# Technical Service Information

## FORD E4OD, 4R70W, 4R44E, 5R55E NEW DIGITAL TRANSMISSION RANGE (DTR) SENSOR FOR SOME 1997 MODELS

Figure 1

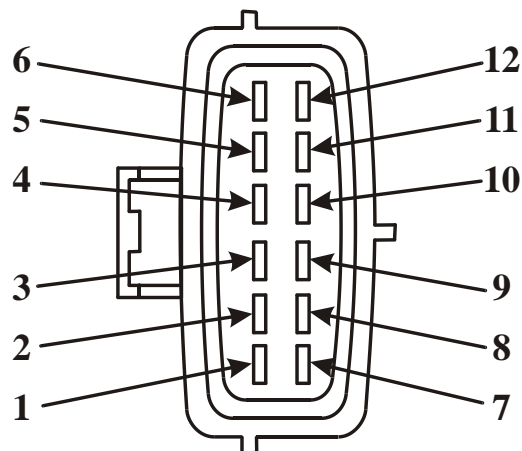
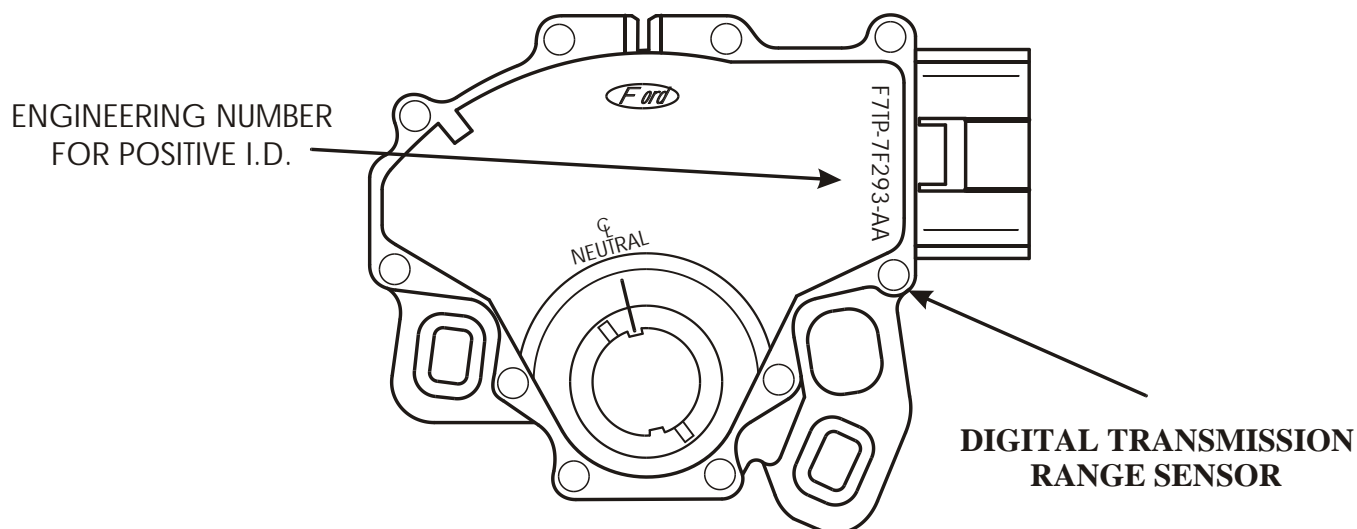
**CHANGE:** Beginning at the start of production for 1997, some vehicles will be equipped with a new Digital Transmission Range (DTR) sensor, and externally looks identical to the previous Manual Lever Position Sensor (MLPS). Refer to Figure 1.

- (1) DTR SENSOR - Replaces the previous manual lever position sensor and is identified by the new basic part number which is -7F293-, as shown in Figure 1. The prefix and suffix will be different depending on the vehicle model and transmission type. The **only positive** identification will be the F7TP-7F293-AA engineering number on the DTR in the location shown in Figure 1.

In Figure 1 we have provided you with pin number identification for both the transmission range sensor and the vehicle harness connector, and a chart that will give you the function of each pin.
